7th February 2020

Application Number **125663/LO/2019**

Potato Wharf Blocks 3 & 4, Castlefield, Manchester
Applications for Listed Building Consent

b. Extract taken from L-0300

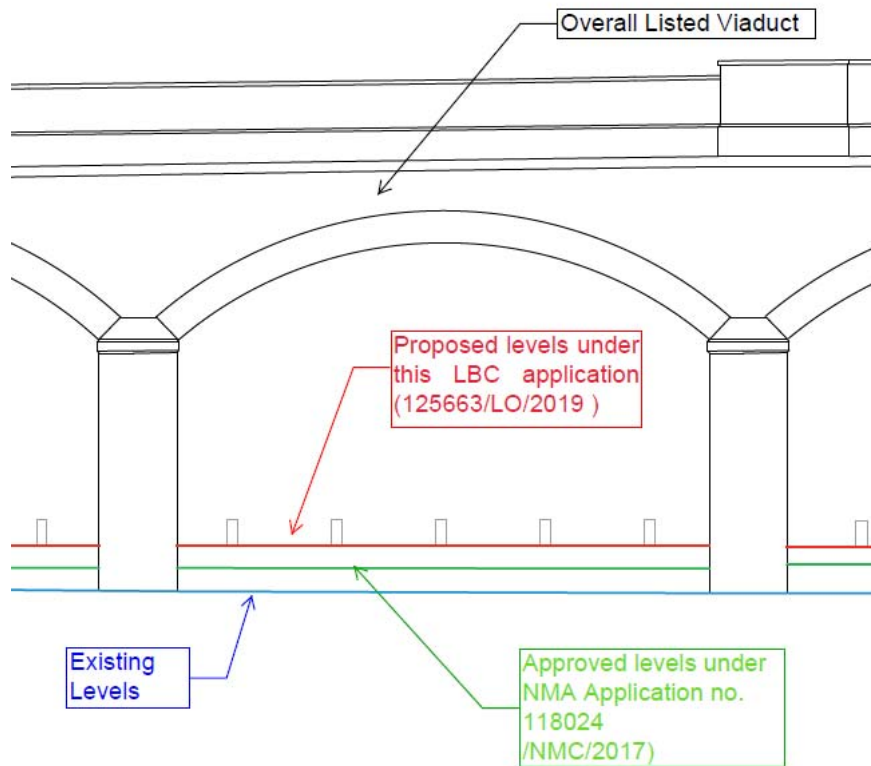
- 2) Heritage Statement should be expanded to assess the physical impact of the proposed changes on the viaduct.
 - a. Following discussions with the planning authority, the client / contractor has agreed to minimise the overall increase in height being proposed so that the increase between the original approval (under 109335/LO/2015/C1) and what is now proposed is no more than 1m. Please also note that further surveying of the site has shown that the existing levels are in places higher than original thought anyway – take Section A of drawing 254173-LPP-90-SW-L00-SEC-L-0301 Rev P4 as an example. The below diagram and photo gives these changes context. Additional test has been added to the Heritage Statement to cover this.
